Informal document **GRSG-115-10-Rev.1**
(115th GRSG, 9-12 October 2018
Agenda item 6(b))

Revised proposal for a new UN Regulation on uniform provisions concerning the approval of motor vehicles with regard to the Blind Spot Information System for the Detection of Bicycles

(Amendments to ECE/TRANS/WP.29/GRSG/2018/24 as adopted by GRSG at its 115th session)

Figure 1
Dynamic tests

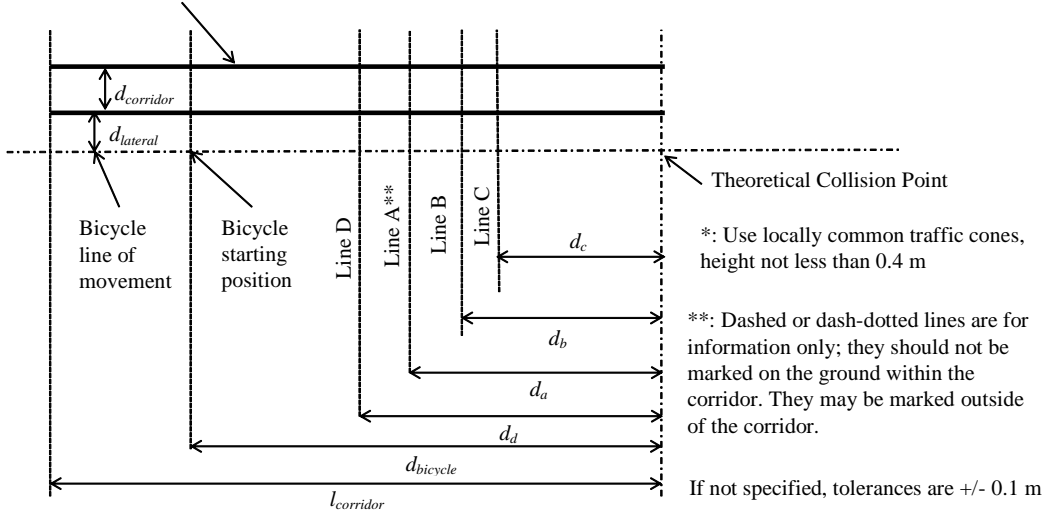
Opmerking [s5]: Test cases 2 and 7: d_c and d_d are not the worst cases (see last sentence of 6.5.10. "conflicting requirements" → other impact points and radii would lead to earlier d_c and d_d values.

Option 1): Change 2 and 7 to be impact position 6 (then 6+7 are identical)
 Option 2): Change d_d in 2 and 7 to be the most stringent values
 Option 3): Delete case 2 and 7.

Opmerking [s8]: Highest value for d_d reached for $R=5, L=0$ (also for test case 2) → Option 2 from the comment above.
